Economic Commission for Europe**Inland Transport Committee****World Forum for Harmonization of Vehicle Regulations****Working Party on Lighting and Light-Signalling****Ninety-second session**

UN Regulation No. 48 (Installation of Lighting and Light-Signalling Devices)

**Proposal for a Supplement to the 09 series of amendments to
UN Regulation No. 48****Submitted by the experts from the International Automotive Lighting
and Light-Signalling Expert Group ***

Figure 1
Duration of the answer-back signal

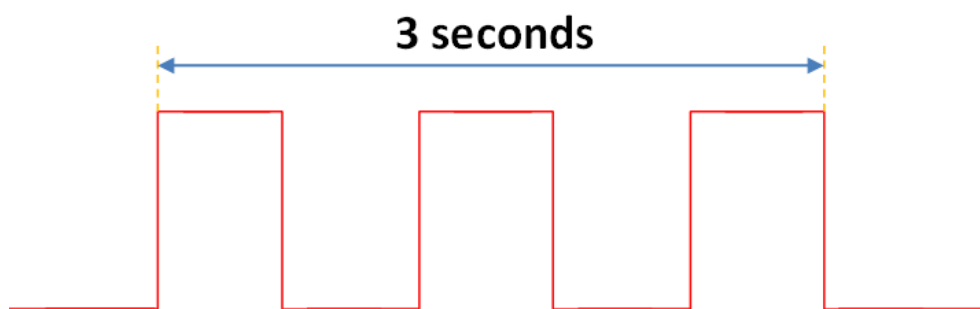
1. To avoid misinterpretations with regard to the timing defined for the duration of the optical indication of the answer-back signal (3 seconds), it is necessary to clarify the beginning and the end of the optical signal in cases where the answer-back signal flashes, varies intensity or in apparent surface.
2. The proposed text to be added avoids the possibility to count only the ON time (without the OFF time) of the signal when determining that the duration of the optical indication of the answer-back signal is limited to 3 seconds.

- 6.27.9.3. The lamp used for the answer-back signal may flash and/or vary in luminous intensity and/or vary in apparent surface.
- 6.27.9.4. The duration of the optical indication of the answer-back signal shall not exceed 3 seconds. **This time is defined from the beginning to the end of the signal, irrespective of whether it contains flashes, variations of intensity or variations in apparent surface.**
